Engineering and Other Services for the Marine Export of Solid Waste

Study of the Friends of the Hudson River Park Pier 76 Concept

**Prepared for the
New York City Department of Sanitation**

July 2007

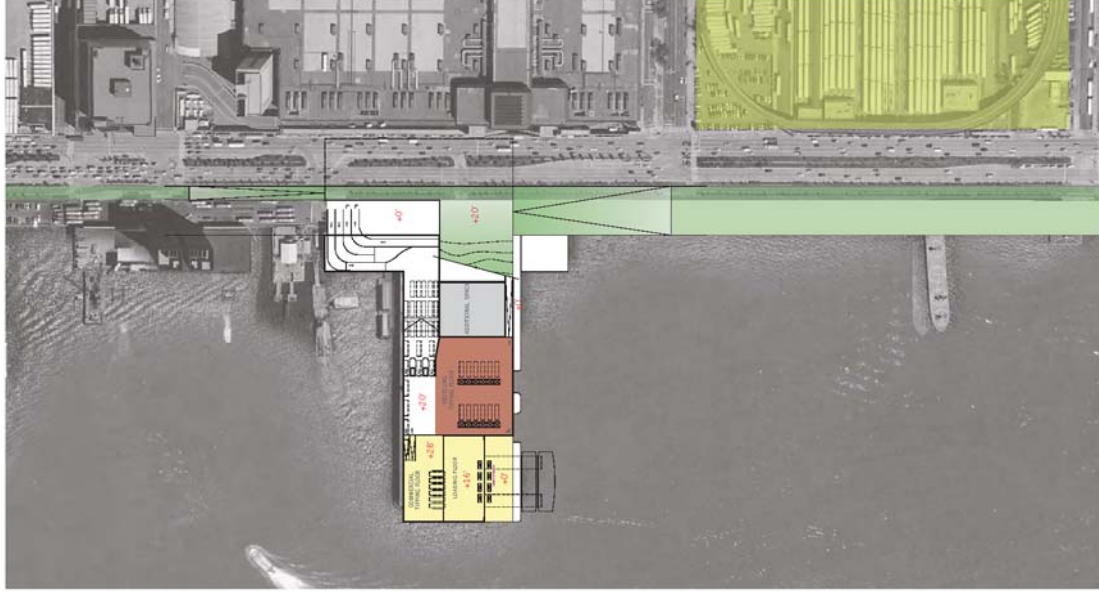
The proposal does not define an exact slope for the walkway and bike path; however, it is not unreasonable to assume that a 5% slope (i.e., 1 foot of rise for each 20 feet of length) would be the maximum grade that would be comfortable for pedestrians, the handicapped and cyclists to negotiate. At that slope a distance of 400 feet would be needed to rise the necessary 20 feet from existing grade. Essentially, this means for nearly 400 feet to the north and south of Pier 76 the eastern and western edge of the Hudson River Park walkway and bike path would be walls. There appears to be sufficient space available for this concept to the south of Pier 76. To the north, however, it appears the implementation of this concept would block access to an excursion boat dock and impinge upon a tourist bus staging area. Consequently, it is clear that while this concept would eliminate a safety concern, it cannot be implemented without imposing at least considerable visual and other impacts and complicating traffic and pedestrian movements to the north of Pier 76.

Tipping Floor Plan

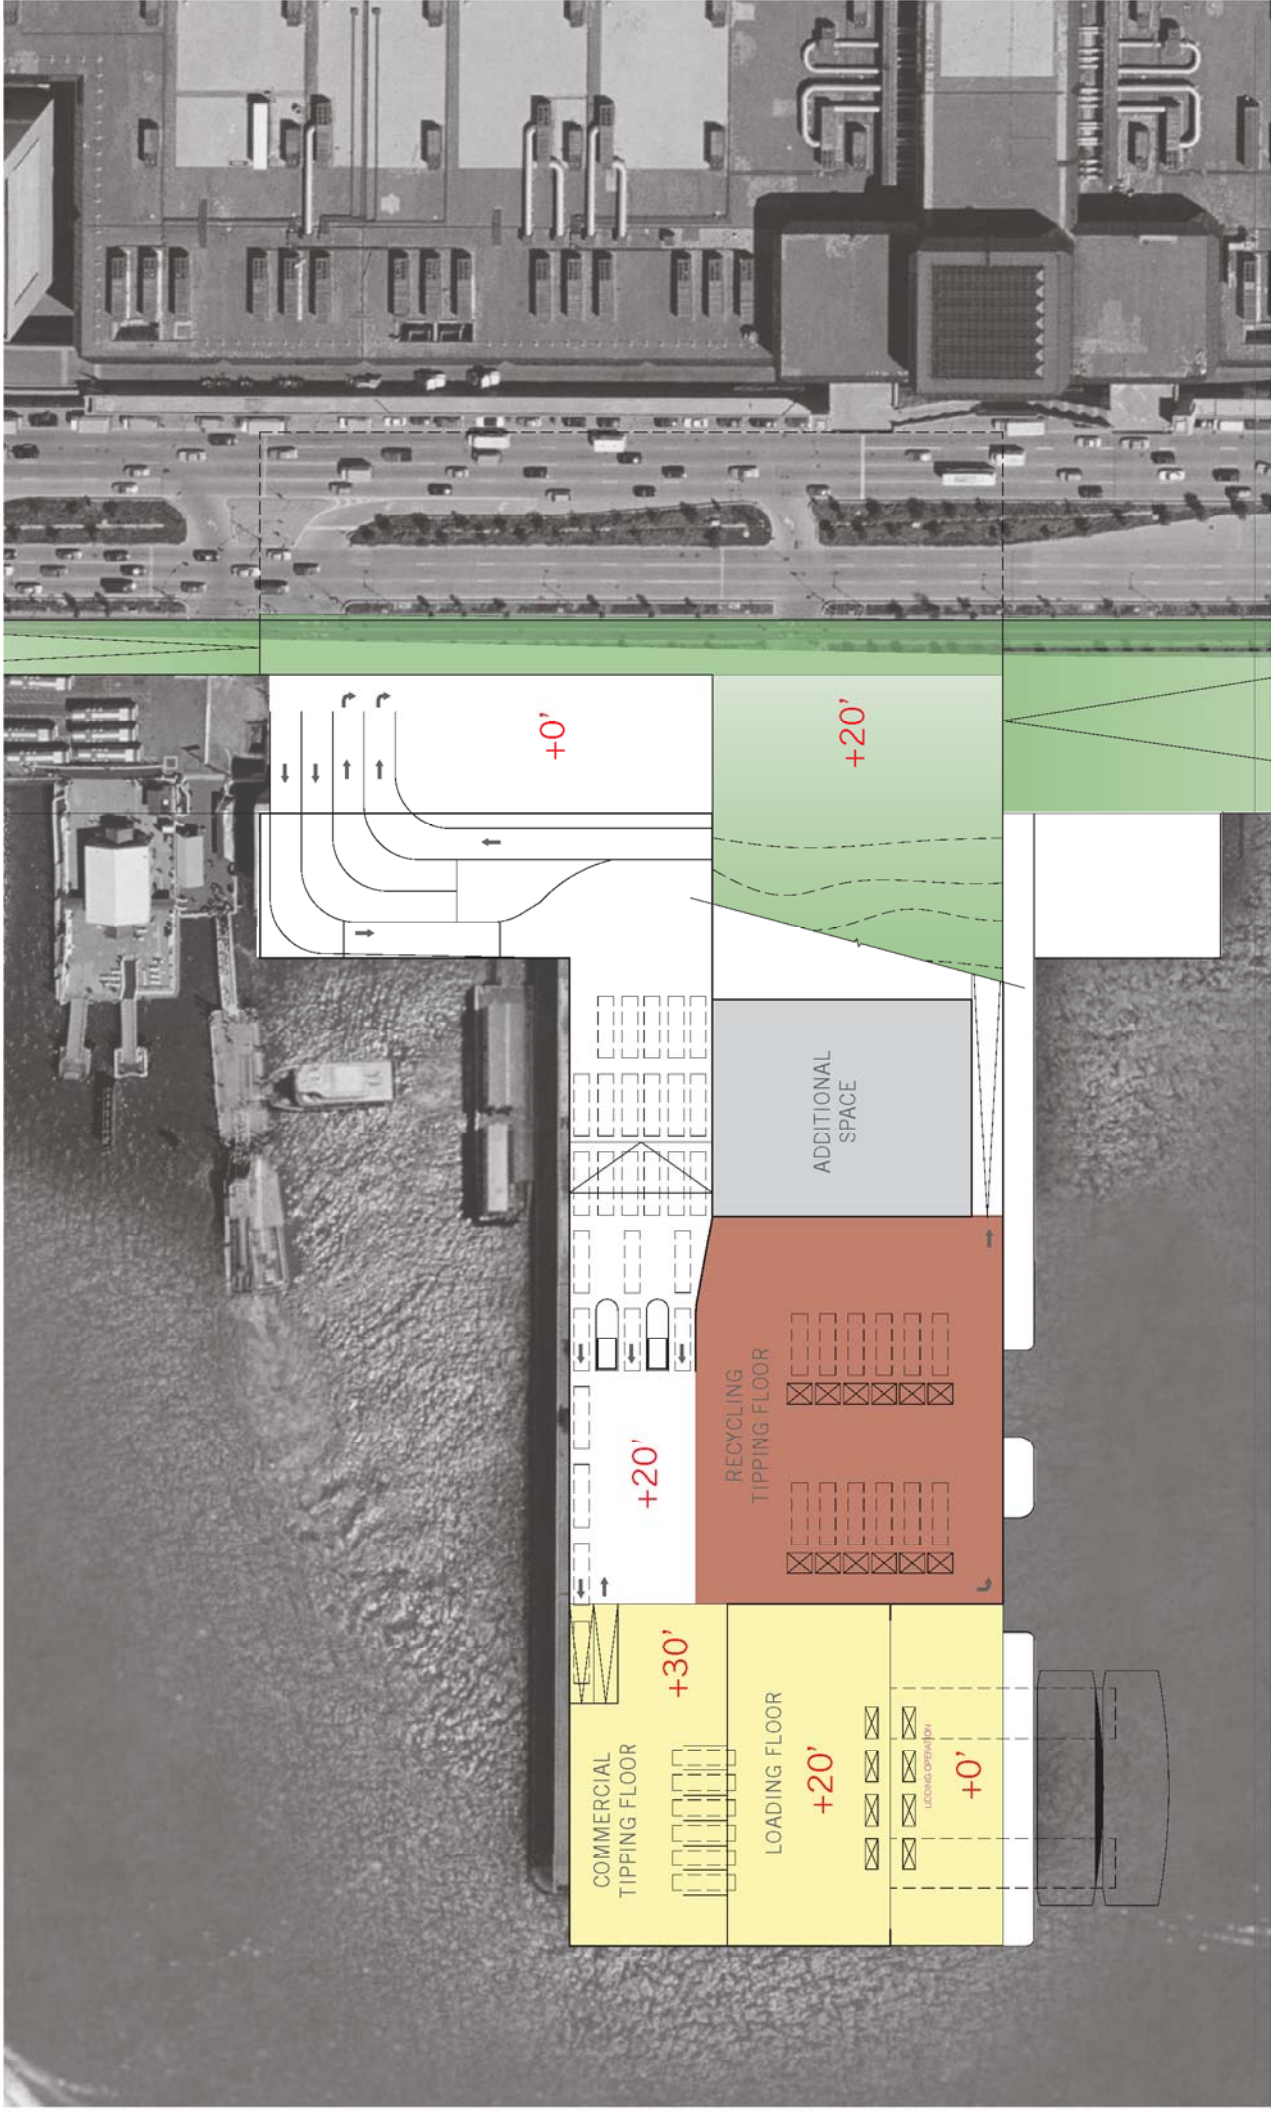
As shown, the distance from the solid waste tipping floor to the top of the rooftop park is 30 feet. This is insufficient clearance to allow for the collection vehicles to raise their tailgates, provide for structural long-span support of the roof and park structures above and incorporate building systems such as fire protection, dust suppression, HVAC ducts and lighting. It is therefore probable the elevation of the rooftop park could exceed +70 feet.

Depending on the framing configuration, the overall depth of the floor slab and framing at the proposed recyclables tipping area would need to be on the order of 4 to 5 feet deep due to the heavy loads on the truck rear axles when tipping and the long clear spans needed. The structure thickness shown in the Pier 76 proposal appears to be much less. Hence, the proposed recycling tipping floor height of 20 feet above the pier level may not be sufficient to accommodate full and empty barges during expected tidal conditions. As a result, the proposed elevation of the recyclables tipping floor as well as the elevation of the roof above it may need to be increased.
